10-E-23-HZ
APPLICATION FOR CERTIFICATE OF APPROPRIATENESS

1701 Emoriland Blvd. 37917
Fairmont-Emoriland NC

Staff Report

File Number: 10-E-23-HZ

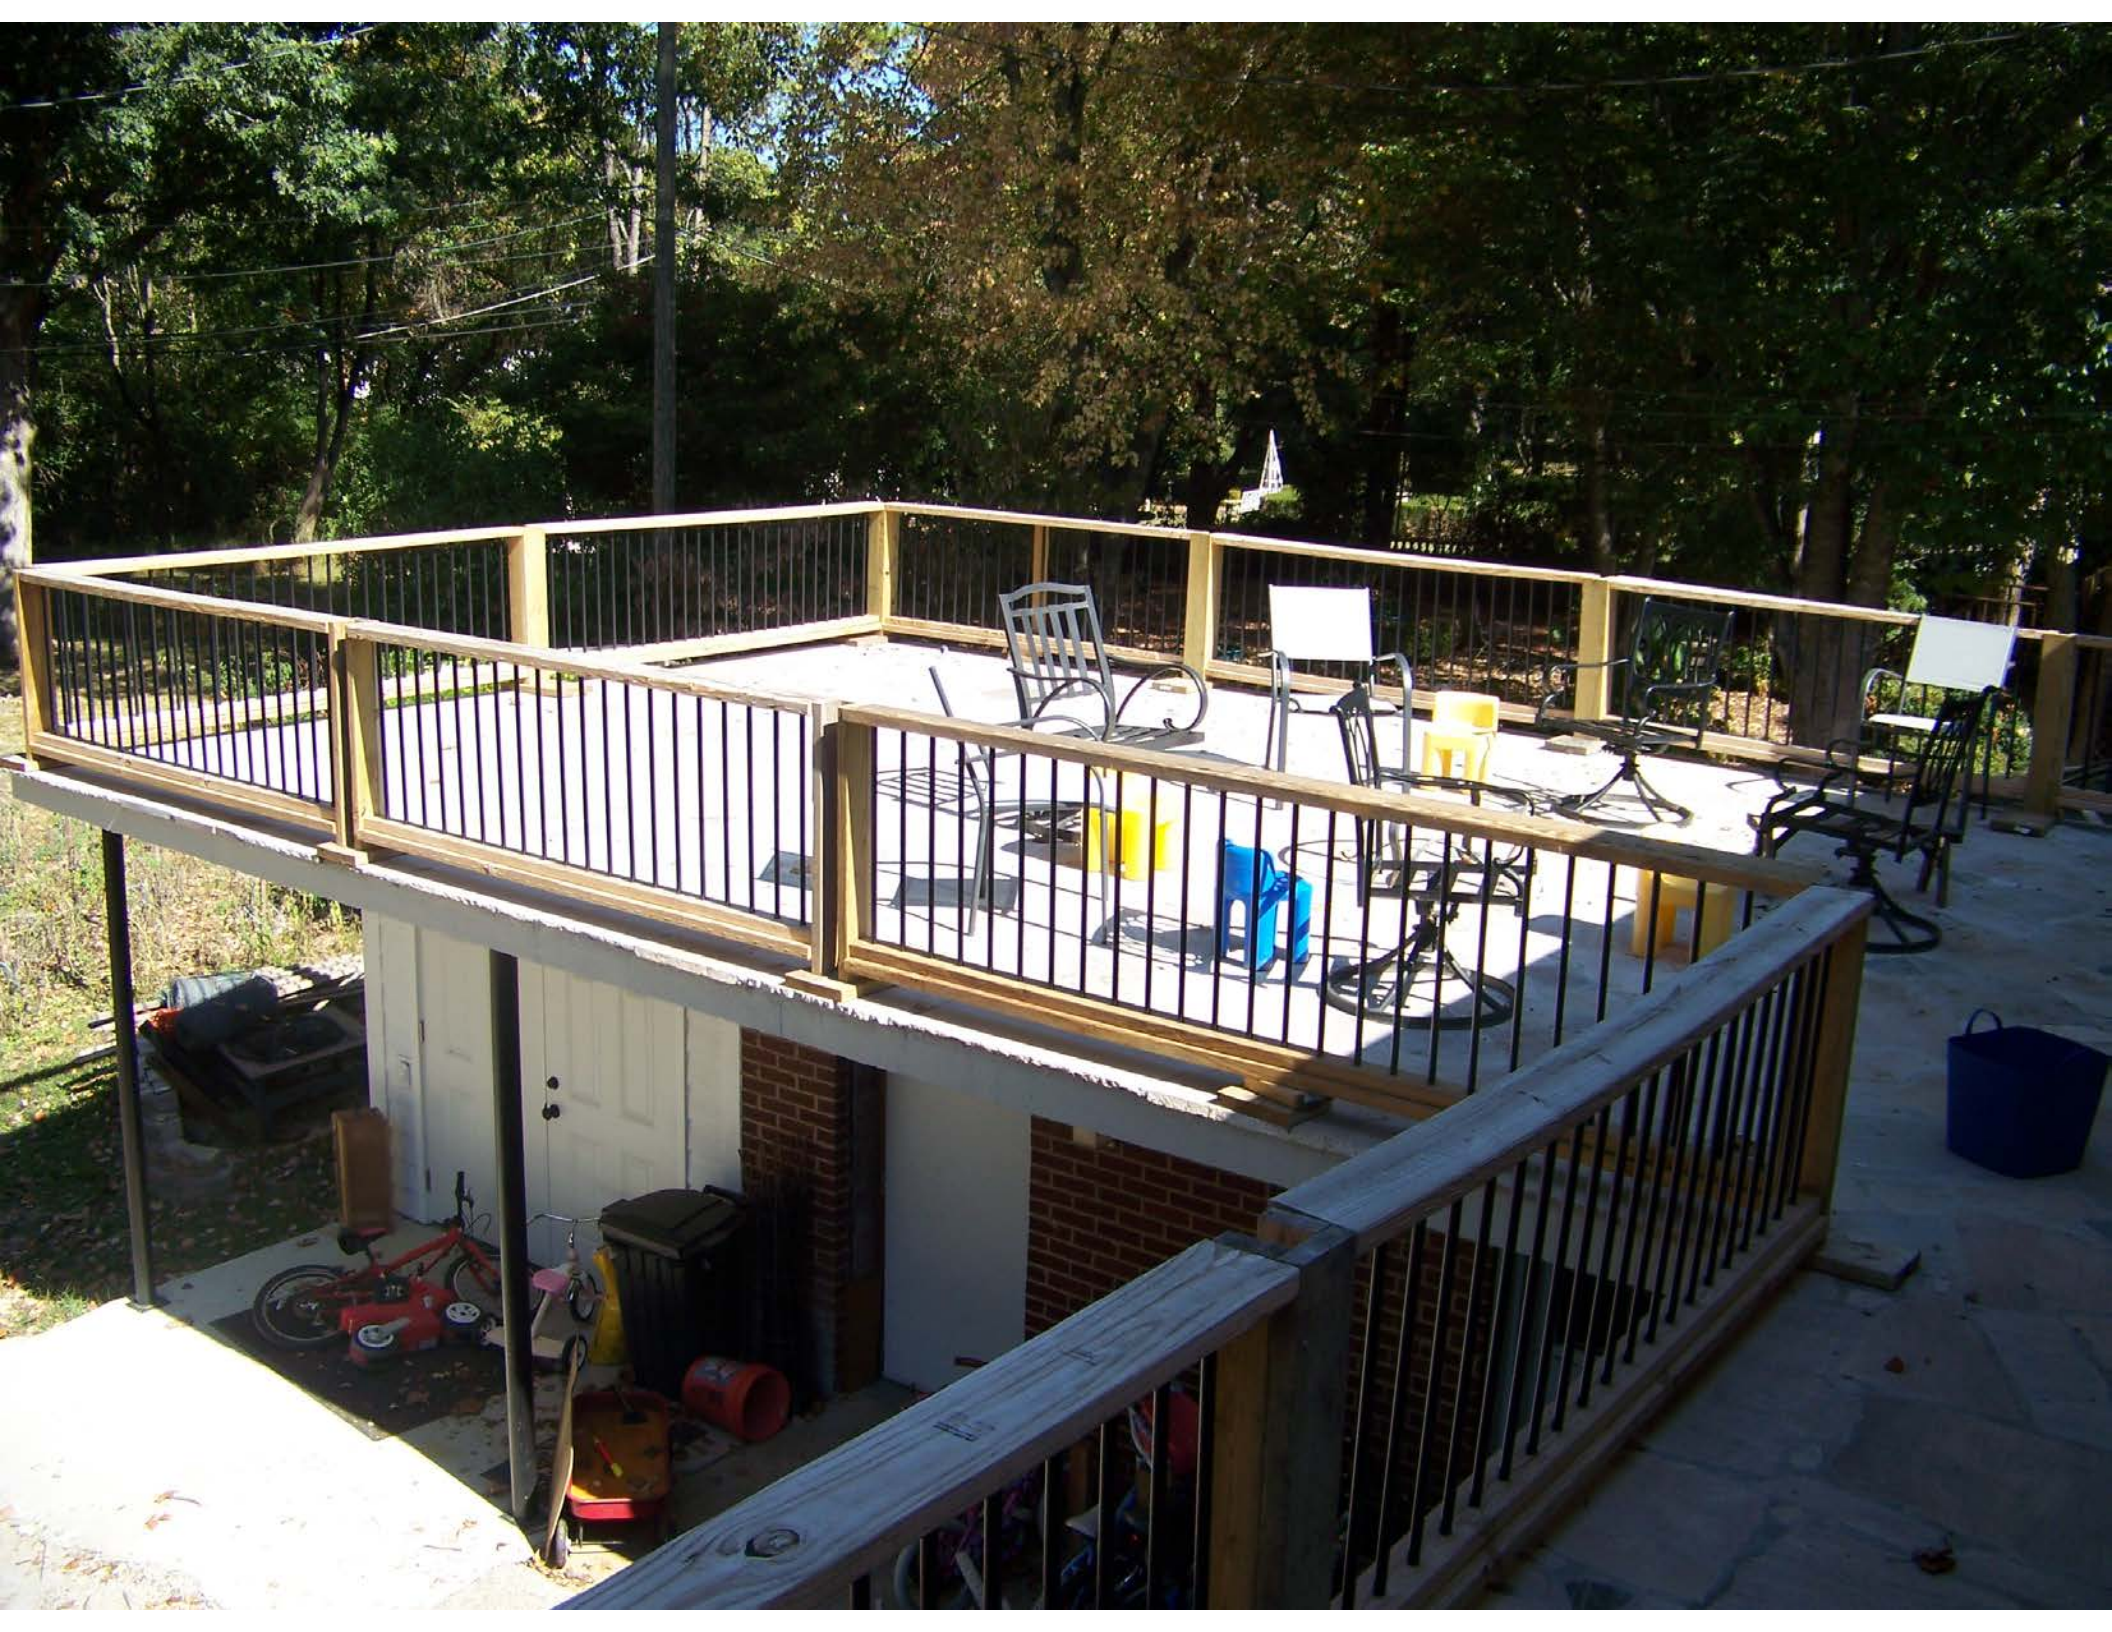
Proposal is to fasten existing wooden railings with aluminum balusters to rear elevated patio. Previous wrought iron railing on the patio has been removed. The height of the railings is unspecified. The proposal also calls for the construction of a metal roof over the patio, supported by six 6x6 wooden posts. The exact square footage of the proposed roof structure is not indicated, although it is mentioned to cover only half of the existing patio.

1. 1701 Emoriland Blvd is a contributing resource to the Fairmont Park NC overlay.
 2. The proposed railings are compatible with the main house and will be minimally visible from the street. The balusters are set into the top and bottom rails instead of nailed to the sides.
 3. The proposed roof structure is not related to the roofline or architectural style of the primary house (a Ranch house). It will be minimally visible from the right-of-way, as the site's topography slopes to the rear. It could be removed without effect on the primary structure.
 4. The drawings provided for HZC review lack some details. The applicant should provide information on the roof pitch and height of the proposed structure. The porch roof structure should be confirmed to be lower in height at the roof peak than the primary structure, to minimize visibility from the right of way.
-

Staff recommends approval of Certificate 10-E-23-HZ, subject to the following conditions: 1) applicant to provide final elevation drawing and site plan to staff for approval; 2) overall height of roof structure to be less than the height (to roof peak) of the primary structure.
